# Work Order ID 97857

Item Name: Crosstube Assembly, Mid Aft

DART AEROSPACE LTD HAWKESBURY, ONTARIO, CANADA	
DRAWING NO. D206-667-247	REV. A SHEET 1 OF 4
TITLE CROSSTUBE ASS'Y (206L MID AFT)	SCALE NTS

DRAWING NO. D206-667-247	TITLE CROSSTUBE ASS'Y (206L MID AFT)	REV. A	<b>DART AEROSPACE LTD ENGINEERING ORDER</b>		D.E.O. NO. D206-667-247-A-1	SHEET NO. SHEET 1 OF 1	SCALE NTS
DRAWN qp	CHECKED ASS	MFG. APPR. KD	APPROVED JMP		DE APPR. H		
DATE 11.07.15	DATE 11.07.20	DATE 11.07.21	DATE 11/07/21		DATE 11.07.21

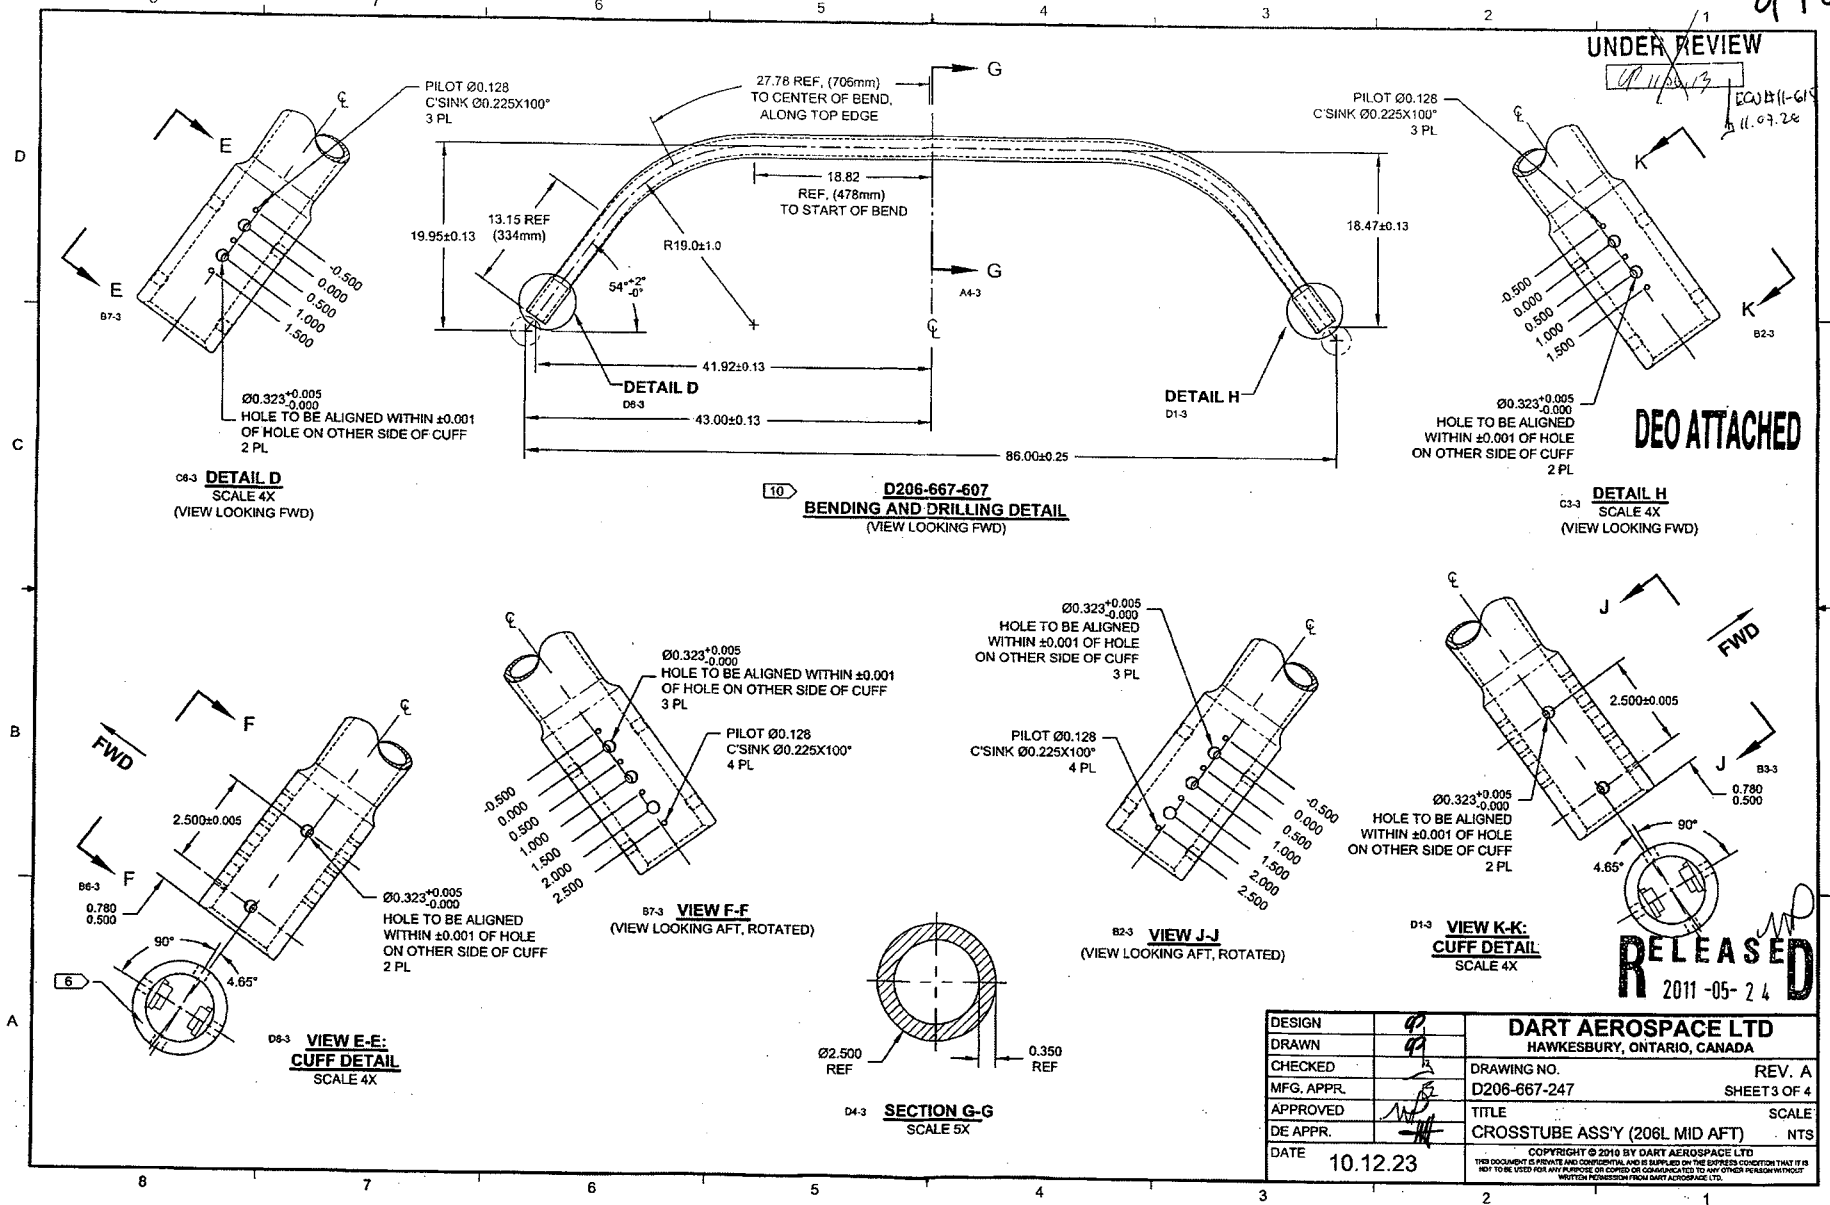
**PURPOSE:**

REPLACE MAGNOBOND WITH PROSEAL

IS:

Item	Qty -247	Part Number	Description
9	A/R	PROSEAL 890 B-2	SEALANT, AMS-S-8802 CLASS B-2

WAS:

9	A/R	MAGNOBOND 6398	ROCKWELL SPECIFICATION RBO-120-023 ADHESIVE (TEXTRON/BELL SPEC. 299-947-100, TYPE II, CLASS 2 ADHESIVE)
---	-----	----------------	---

NOTE 12 & 15, SHEET 1 IS AMENDED AS FOLLOWS:

WAS:

- 12) INSTALL D2892-1 SUPPORT USING 0.03" TO 0.06" THICK LAYER OF MAGNOBOND 6398 PER QSI 015. LET CURE FOR 12 HOURS AFTER INSTALLATION AND PRIOR TO PACKAGING.
- 15) TORQUE CLAMPS 80 TO 100 IN-LB. ENSURE AT LEAST 1.5 THREADS SHOWING IN SAFETY AND THAT NUT HAS NOT BOTTOMED-OUT AFTER TORQUING.

IS:

- 12) TO INSTALL D2892-1 SUPPORT: ABRASE MATING SURFACE OF SUPPORT AND CROSSTUBE WITH 180-GRIT SANDPAPER AND REMOVE RESIDUE WITH MEK (OR EQUIVALENT). APPLY A 0.04" TO 0.07" THICK LAYER OF PROSEAL 890 CLASS B-2 (OR AMS-S-8802 CLASS B-2) SEALANT TO MATING SURFACE OF SUPPORT.
- 15) TORQUE CLAMPS 80 TO 100 IN-LB. ENSURE AT LEAST 1.5 THREADS SHOWING IN SAFETY AND THAT NUT HAS NOT BOTTOMED-OUT AFTER TORQUING. **PRIOR TO PACKAGING, RE-CHECK TORQUE ON CLAMPS AFTER PROSEAL 890 SEALANT HAS CURED FOR 72 HOURS.**
